Agenda Item # 12

SUB-003750-2026

Cavallo Ridge Subdivision

- Subdivision approval to create 141 legal lots of record from four (4) metes-and-bounds parcels.

DETAIL SITE PLAN

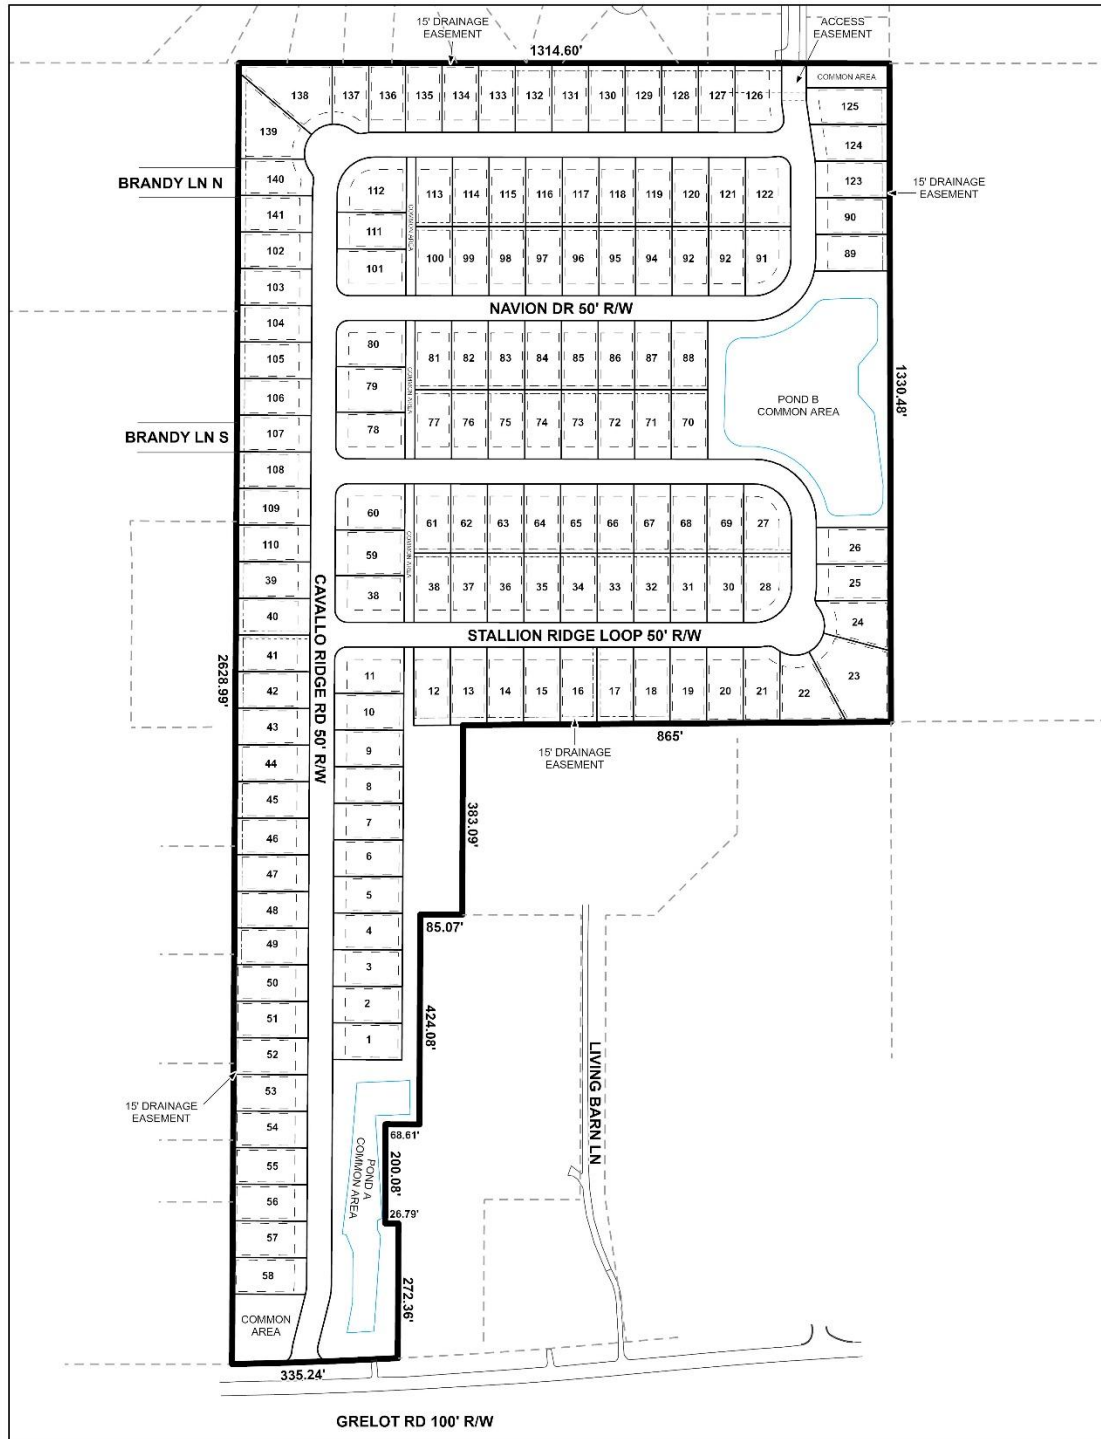
Access to the proposed subdivision is from Grelot Road, a Minor Arterial Street requiring a 100-foot-wide right-of-way at this location. A 100-foot-wide right-of-way is depicted on the preliminary plat, making additional dedication unnecessary.

Two (2) streets and an extension to Navion Drive are proposed for public dedication within the subdivision, labeled as *Cavallo Ridge Drive*, *Stallion Ridge Loop*, and *Navion Drive*. Each proposed street is depicted with a 50-foot-wide right-of-way, which is compatible with Section 6.B.9. of the Subdivision Regulations for streets equipped with curb and gutter.

Additional right-of-way is provided along portions of *Stallion Ridge Loop* and *Cavallo Ridge Drive* to accommodate partial turnarounds adjacent to proposed Lots 22, 23, and 24, and Lots 137, 138, 139, and 140. Although the dimensions of these rights-of-way are not labeled, they exceed the minimum 50-foot width required for streets with curb and gutter. If approved, the dimensions of these additional rights-of-way should be labeled on the Final Plat.

All proposed street names must be approved by the City Engineer to avoid duplication. Any revisions to the proposed street names, or the assignment of additional names to distinguish portions of a street, such as the northern segment of *Stallion Ridge Loop*, should be reflected on the Final Plat, if approved.

Proposed Lots 11, 27, 28, 38, 60, 78, 80, 91, 101, 112, 122, and 126 are corner lots subject to the 25-foot corner radius requirement of Section 6.C.6. of the Subdivision Regulations. A curve data table on the preliminary plat indicates that each corner lot provides a radius meeting or exceeding this requirement; therefore, no additional dedication is necessary. This table should be retained on the Final Plat, if approved.

Two (2) common areas are also located at the intersection of *Cavallo Ridge Drive* and Grelot Road. According to the curve data table, each provides a 25-foot corner radius, satisfying the requirements of Section 6.C.6. This information should also be retained on the Final Plat, if approved. As proposed, each of the lots will meet the minimum size requirement of Article 2, Section 64-2-5.E. of the Unified Development Code (UDC) for lots served by public water and sanitary sewer in the R-1 Suburban district. Lot sizes are labeled in both square feet and acres on the preliminary plat, as required by Section 5.A.2.(e)(4) of the Subdivision Regulations. If approved, this information should be retained on the Final Plat or provided in an accompanying table.

All but three (3) of the proposed lots meet the minimum 60-foot lot width requirement of Section 6.C.2(b)(2) of the Subdivision Regulations for residential lots within the Suburban sub-district. Proposed Lots 23, 138, and 139 have widths of approximately 49.13 feet, 47.87 feet, and 53.06 feet, respectively. Because these lots abut the proposed partial turnarounds, resulting in wedge-shaped configurations, but continue to satisfy the minimum lot area requirements of the UDC, a waiver of Section 6.C.2(b)(2) may be appropriate and will be required to accommodate the reduced lot widths, if approved.

Four (4) common areas are provided, each with their sizes labeled in square feet and acres on the preliminary plat in accordance with Section 5.A.2.(f) of the Subdivision Regulations. However, the common areas are not sequentially labeled, being identified as "Common Area 1," "Common Area 2," "Common Area 5," and "Common Area 7". If approved, these labels should be revised to provide a sequential numbering system or, alternatively, each area should simply be labeled "Common Area."

Front, side, and rear yard setbacks are depicted on each proposed lot. However, Section 6.C.8. of the Subdivision Regulations only requires the minimum front yard setback to be shown on a subdivision plat. Therefore, all side and rear yard setback lines should be removed from the Final Plat, if approved. In addition, the plat should be revised to depict a 25-foot front yard setback along each existing and proposed street where the adjacent

common area has a width of at least 60 feet, in compliance with Section 6.C.8. of the Subdivision Regulations and Article 2, Section 64-2-5.E. of the UDC. A 25-foot front yard setback should also be depicted along Navion Drive adjacent to the northernmost common area (currently labeled “Common Area 7”), despite that common area being less than 60 feet in width.

Multiple easements are depicted on the preliminary plat, including drainage and access easements. If approved, this information should be retained on the Final Plat along with the provision of a note stating that no structure shall be erected within any easement without the permission of the easement holder.

Finally, Section 7.C.4. of the Subdivision Regulations requires sidewalks to be constructed on both sides of all subdivision streets concurrently with development of each lot, as well as along common areas and other non-lotted areas. The preliminary plat includes a note reflecting this requirement, unless a sidewalk waiver is approved. This note should be retained on the Final Plat, if approved.

1. Retention of the 100-foot-wide right-of-way along Grelot Road, as depicted on the preliminary plat;
2. Retention of the 50-foot-wide rights-of-way along each proposed street, as depicted on the preliminary plat

3. Labeling of the dimensions of the additional right-of-way associated with the partial turnarounds adjacent to proposed Lots 22, 23, 24, 137, 138, 139, and 140, on the Final Plat;

4. Approval of all street names by the City Engineer prior to recording of the Final Plat, with any approved name changes reflected on the Final Plat;
5. Retention of the curve data table demonstrating compliance with the required 25-foot corner radii for all corner lots and common areas on the Final Plat;

6. Retention of lot area labels in both square feet and acres or in an accompanying table on the Final Plat;
7. Revision of the common area labels on the Final Plat to provide sequential numbering or, alternatively, labeling all such areas simply as “Common Area”;

8. Provision of a note on the Final Plat stating that the maintenance of all common areas shall be the responsibility of the property owner(s) and not the City of Mobile;

9. Removal of all side and rear yard setback lines from the Final Plat;
10. Depiction of a 25-foot front yard setback adjacent to all common areas where they are at least 60 feet in width, including the northernmost common area along Navion Drive, despite it being less than 60 feet wide;

11. Retention of all easements on the Final Plat, as depicted on the preliminary plat;
12. Provision of a note on the Final Plat stating that no structure shall be placed within any easement without the permission of the easement holder;

13. Retention of the sidewalk note on the Final Plat stating that sidewalks shall be constructed on both sides of the subdivision's streets and along common areas and other non-lotted areas in accordance with Section 7.C.4. of the Subdivision Regulations, unless a Sidewalk Waiver is approved;
14. Compliance with all Engineering comments noted in this staff report;
15. Placement of a note on the Final Plat stating all Traffic Engineering comments noted in this staff report;
16. Compliance with all Urban Forestry comments noted in this staff report; and,
17. Compliance with all Fire Department comments noted in this staff report.
